Project # 1001206

**Re:** **Tract 3C, Black Ranch Submittal (Project #1001206)**

16. 01128-01749 Rodey Law Firm/Consensus Planning, agents for Presbyterian Healthcare  
01128-01750 Services, request approval of a Site Development Plan for Subdivision, plus  
Project 1001206 approval of a Site Development Plan for Building Permit for Tract 3C, Black  
Ranch, zoned SU-1 for C-1 uses and located on Coors Boulevard NW between  
Paseo del Norte NW and Irving NW, containing approximately 1.2 acres. (C-13)  
Debbie Stover, Staff Planner

<b>Agent</b>	Presbyterian Healthcare Services
<b>Applicant</b>	Rodey Law Firm/Consensus Planning
<b>Requests</b>	<b>Site Development Plan for Subdivision</b>  <b>Site Development Plan for Building Permit</b>
<b>Legal Description</b>	Tract 3C, Black Ranch
<b>Location</b>	Coors Boulevard between Paseo del Norte and Irving Boulevard NW
<b>Size</b>	Approximately 1.2 acres
<b>Existing Zoning</b>	SU-1 for C-1
<b>Proposed Zoning</b>	SU-1 for C-1

PROJECT TITLE <b>JIFFY LUBE</b> Valley View Drive Albuquerque, NM		DRAWN BY: BJ	
PROJECT MANAGER Bill Johnson, AIA	JOB NO. 9125	DATE 1/29/01	
SHEET TITLE <b>Building Elevations</b>

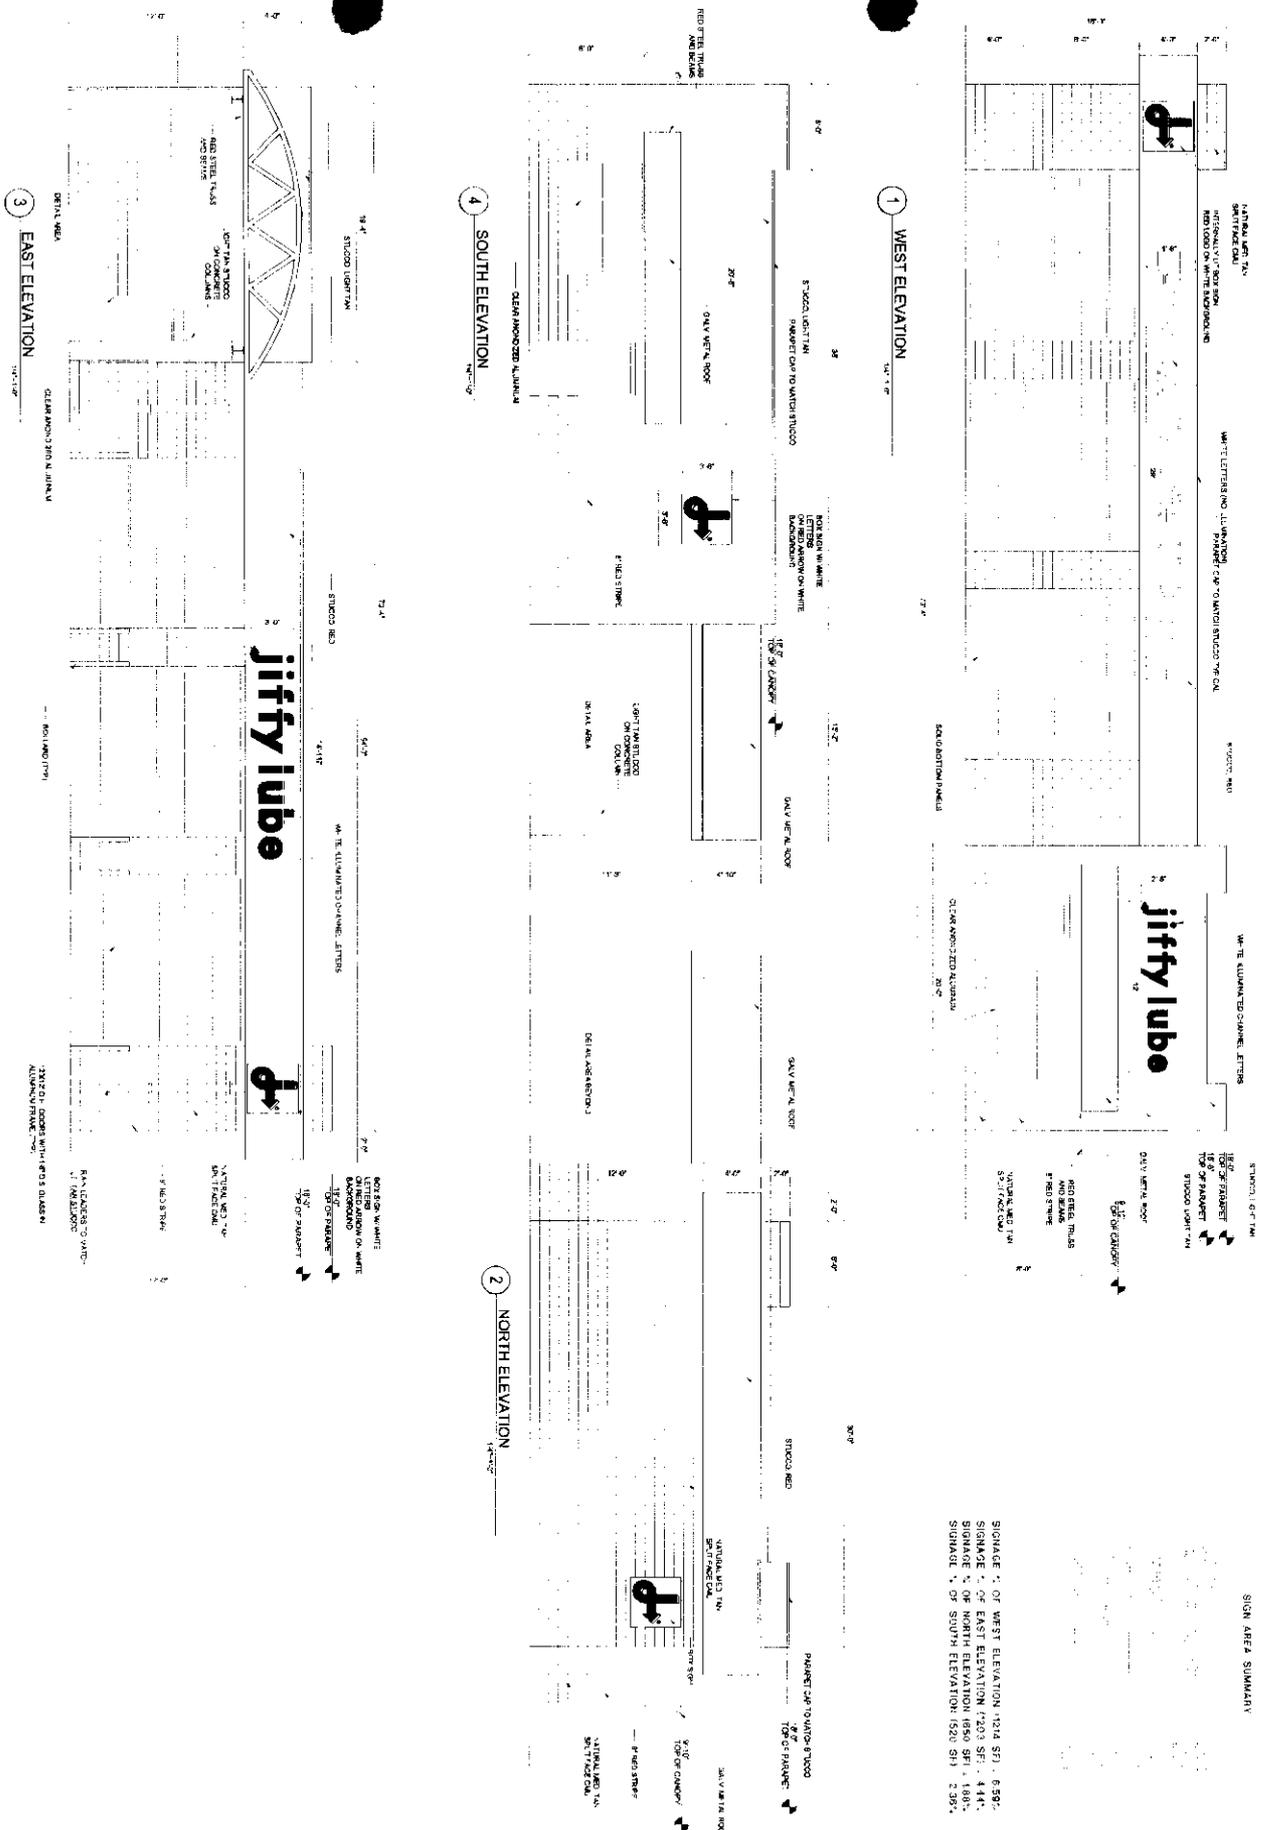
6. Dimensions of all major façade elements will be added to the elevations and these sheets will be replaced.
